MEMORANDUM

To: Development Review Board
From: Mary O'Neil, AICP, Senior Planner *monie*
Date: August 19, 2014
RE: ZP 14-1300CA/CU 85 Lakeview Terrace

Request: Construction of a 2 story addition to existing single family home; remove existing shed and construct new accessory structure for accessory dwelling unit and storage.

Proposed Site Plan
scale: 1/16"=1'

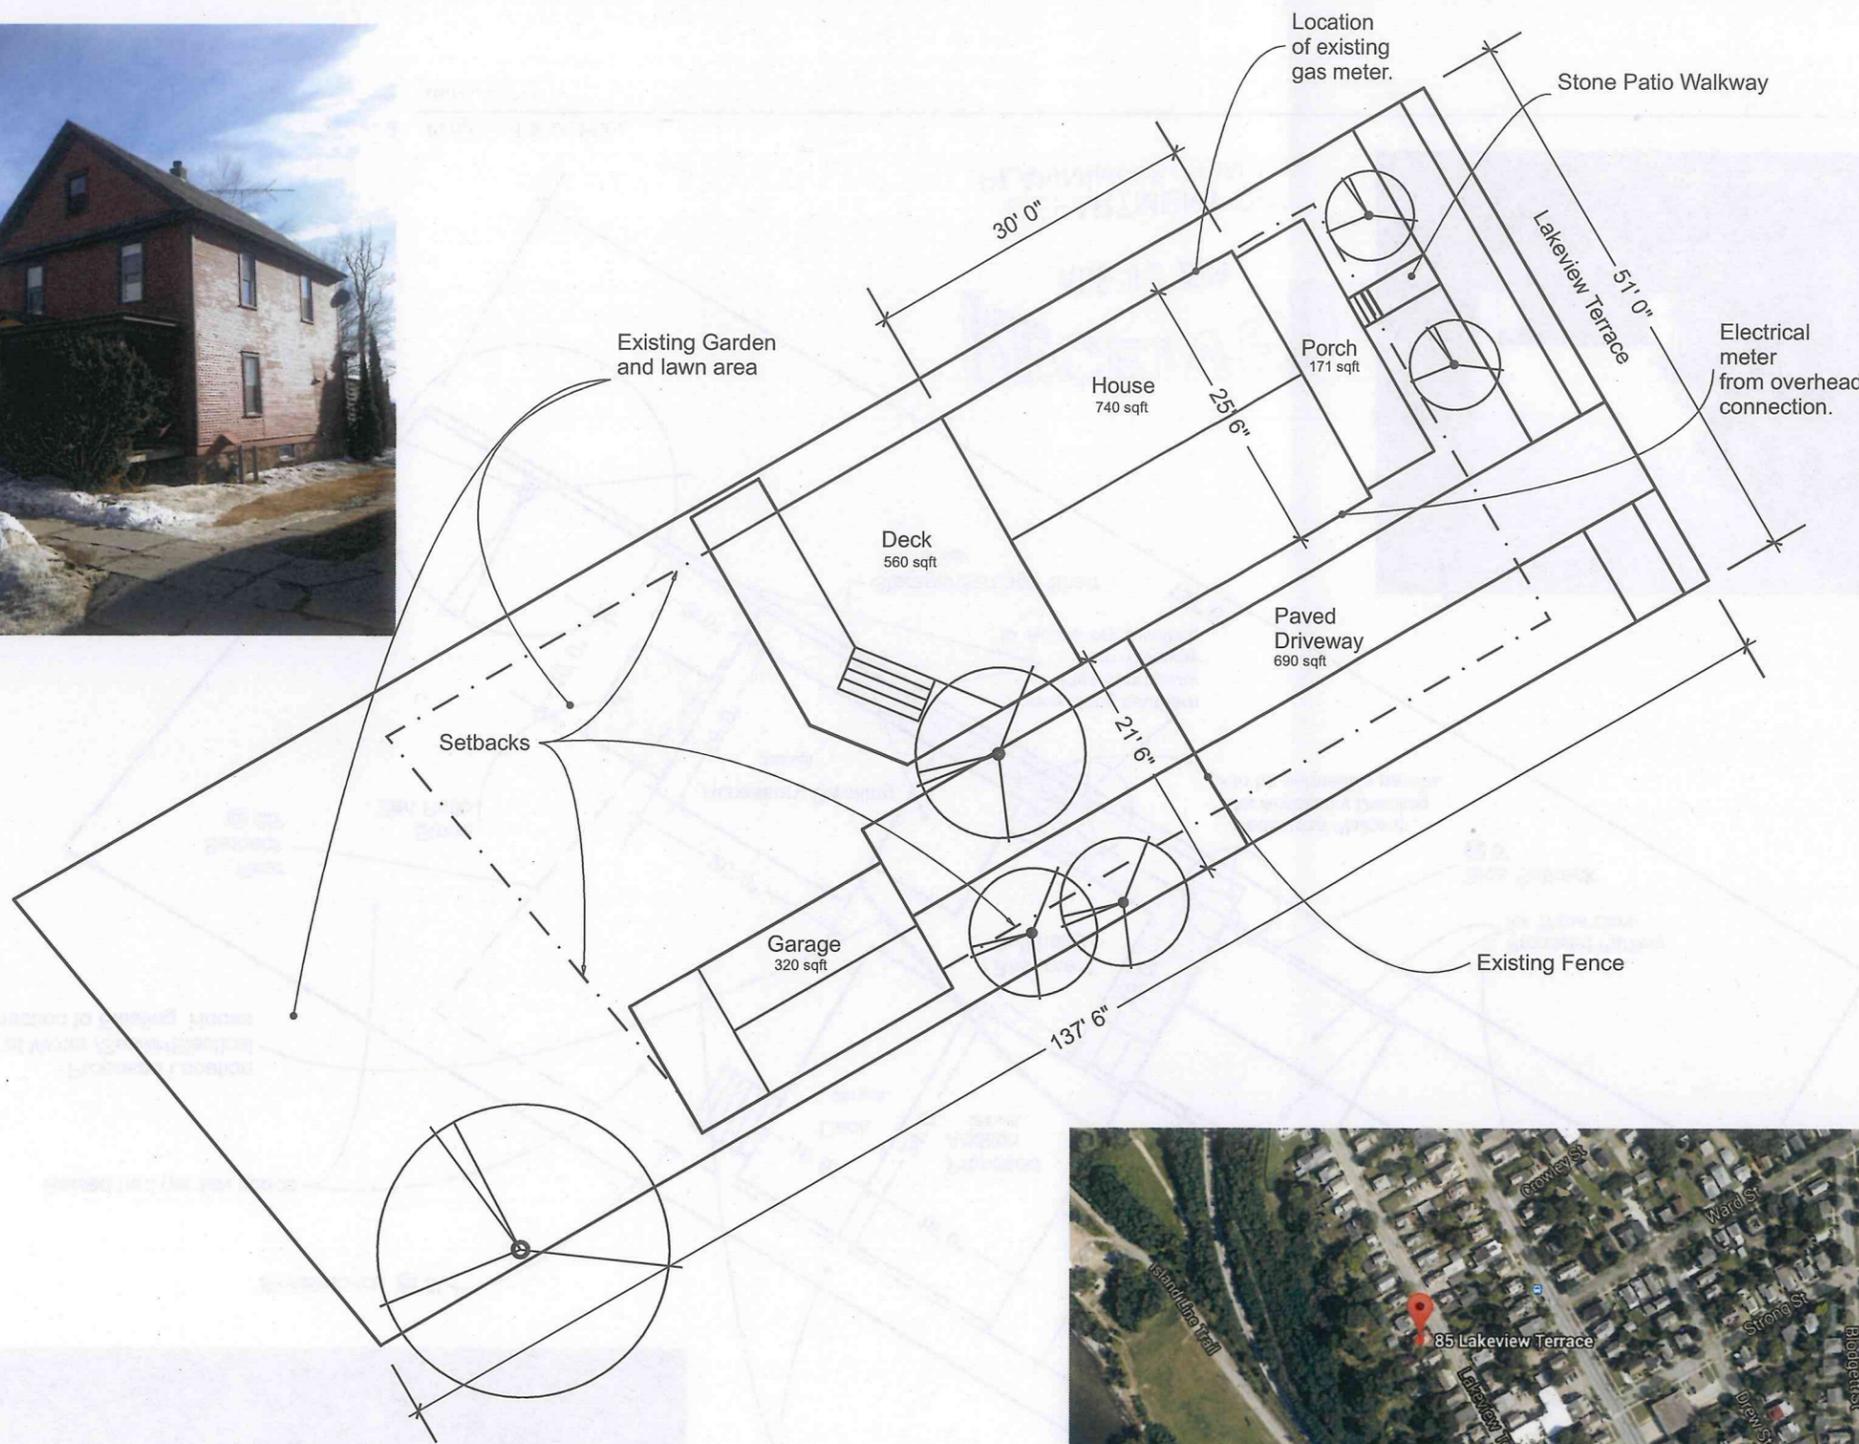
The proposed site plan illustrates a walkway from the parking area/drive to the accessory dwelling (walkways are permitted to encroach within setbacks.) There is a walkway to the primary residence from the public sidewalk. **Affirmative finding.**

The single family home requires 2 parking spaces, and the proposed accessory dwelling unit 1 parking space (Per Zoning Ordinance Amendment 13-10). Three parking spaces are illustrated on the site plan; outside the front yard setback, 2 in tandem to serve the primary residence. The existing curbcut will be utilized. **Affirmative finding.**

A planting box is illustrated at the foot of the rear stairs on modeling studies, and three unidentified trees on the site plan. Areas for raised garden beds have been noted. A fence has been added to the plan along the south elevation (Plan A.06), and illustrated at the head of the driveway (A.08) to provide a modicum of privacy for the ADU. **Affirmative finding.**
